CITY OF OPELIKA
HISTORIC PRESERVATION COMMISSION
December 12, 2024
4:30 p.m.
Meeting Chambers at Opelika Municipal Courtroom
300 MLK Boulevard

City of Opelika
Historic Preservation Commission
Staff Report

Agenda Item #: 1
Meeting Date: 12/12/2024
Action Requested: COA: New Construction; Preliminary Review
Location of Property: 500 2nd Ave; Downtown Historic District
Petitioner: Mazzola Architecture, LLC

Agenda Item #: 2
Meeting Date: 12/12/2024
Action Requested: Façade Renovation
Location of Property: 107 N. 9th St; Downtown Historic District
Petitioner: Stone Martin Builders

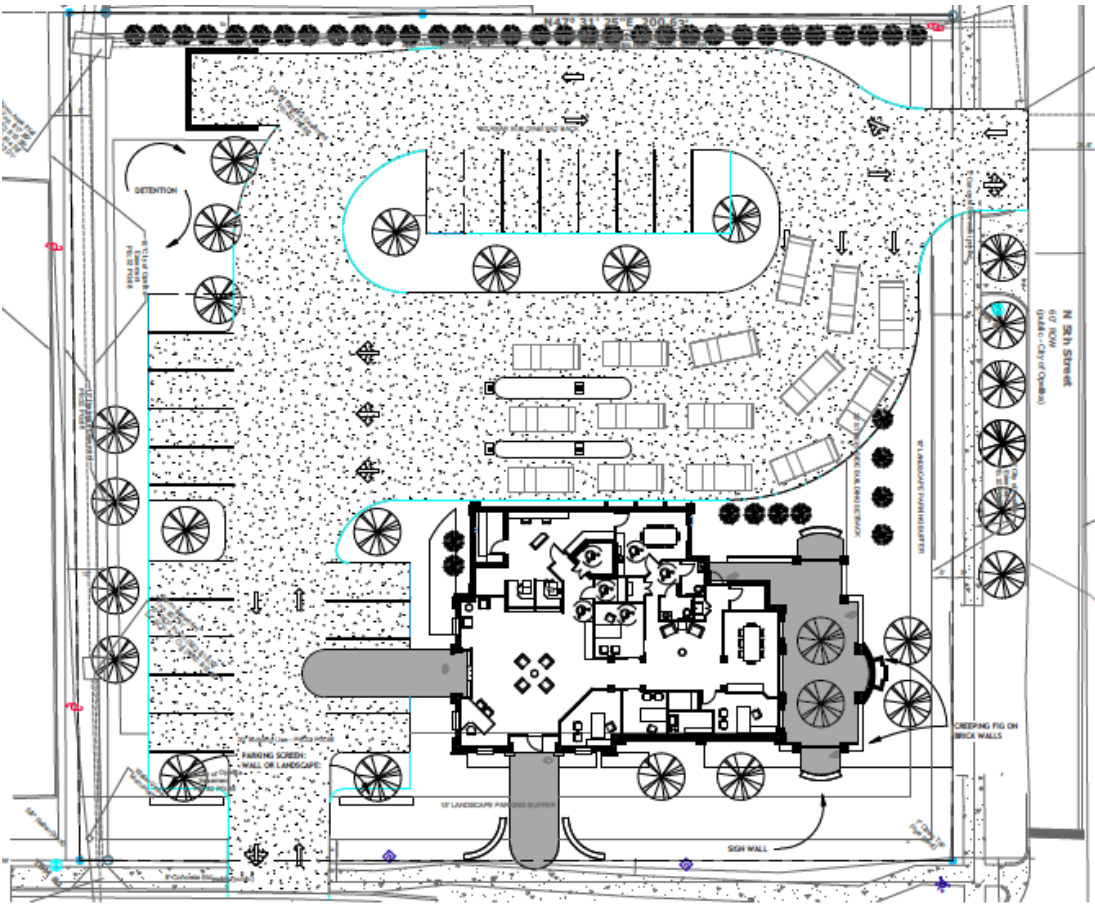
Site plan-building facing 2nd Ave with drivethru in rear and parking interior on lot

Scale: Diagrams show proposed building will be approximately 5ft taller than Bubba's roof ridge and 7ft shorter than PNC Bank ridge.

1. Staff recommends approval of brick commercial building meeting guidelines for material, size/scale, orientation/alignment, and setback. Staff would prefer to see the drive through positioned in the rear, becoming a sub-ordinate feature on the site.
2. Applicant shall return for sign approval.
3. Approval is contingent on the site plan and landscape approval by the Planning Department.

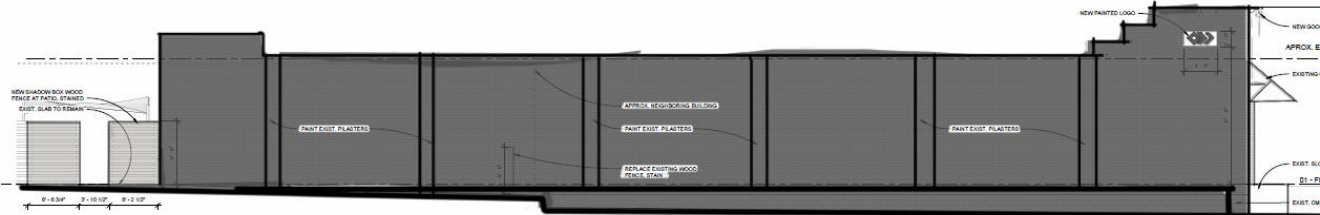
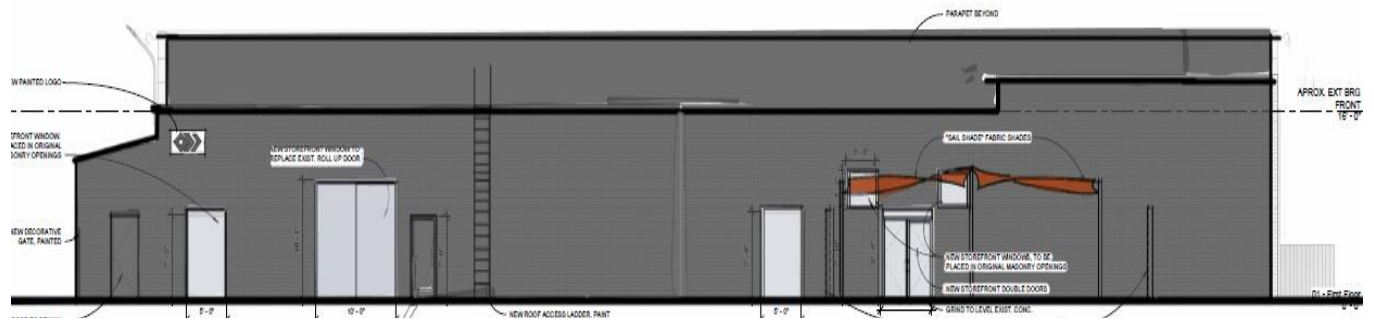
Side view facing 1st Ave, including steel and Trex gate

Side view facing 2nd Ave-shows painted logo, replacing existing wood fence, and new “shadow box” fencing at rear.

Rear view showing reestablished windows, storefront window replacing roll up door, new storefront double doors, and patio area with sail shade canopy

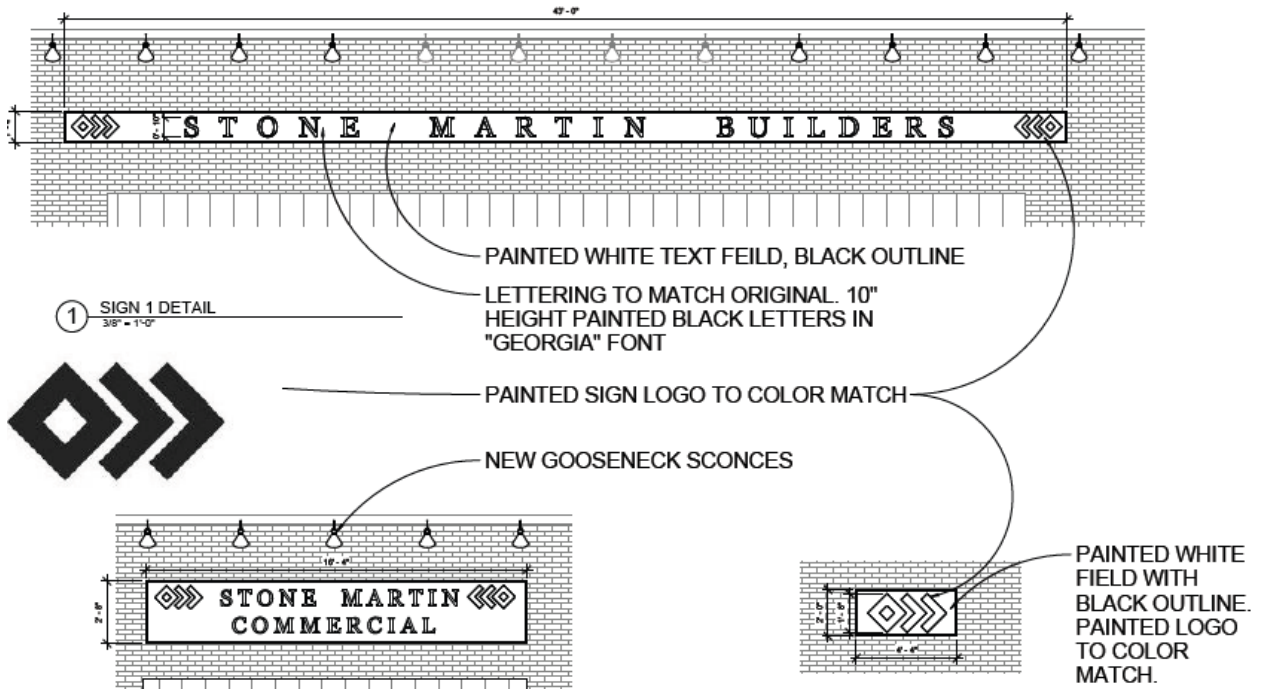
NEW STOREFRONT
WINDOWS AT BACK
ELEVATION.
PRECISION GLASS,
FRONT SET,
ANNODIZED BLACK
Rear windows

BENJAMIN MOORE
2134-30 - IRON MOUNTAIN
ALL EXISTING EXTERIOR
PAINTED BRICK TO BE
REPAINTED

BENJAMIN MOORE
HC-172 - REVERE PEWTER
PILASTERS AT ENTRANCES

DECORATIVE GATE:
TREX COMPOSITE
BOARDS - PREFINISHED
"CLAM SHELL"

WOOD PANEL WALL USA
WOOD TECH - COMPOSITE EXTERIOR PANEL
"TEAK LIGHT BROWN"

FASTENED TO EXISTING MASONRY WALL WITH
SELF-TAPPING (TAPCON) SCREWS

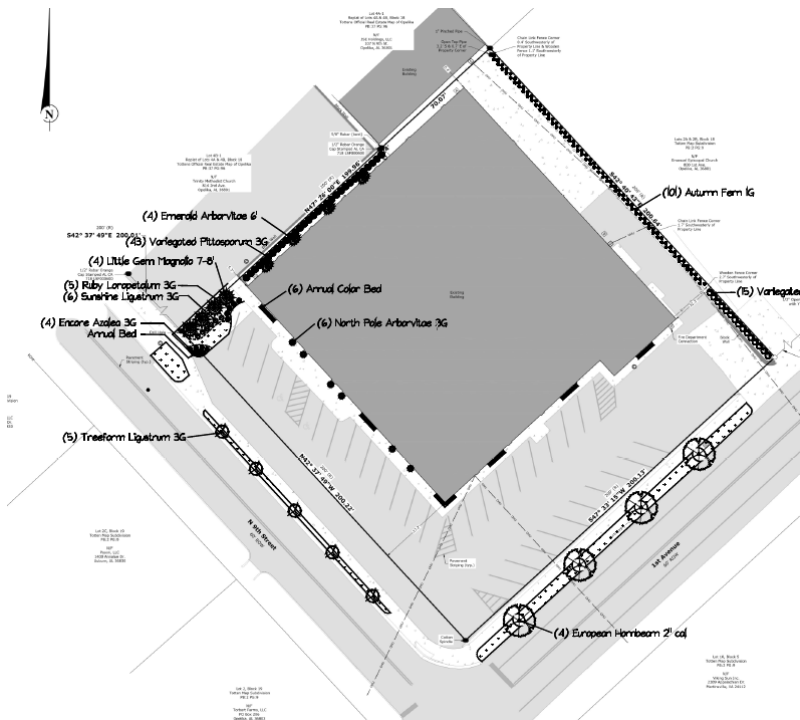
Signage details-front façade signs are 86sf and 48sf (134sf total) and logos are 8.6sf each on sides.
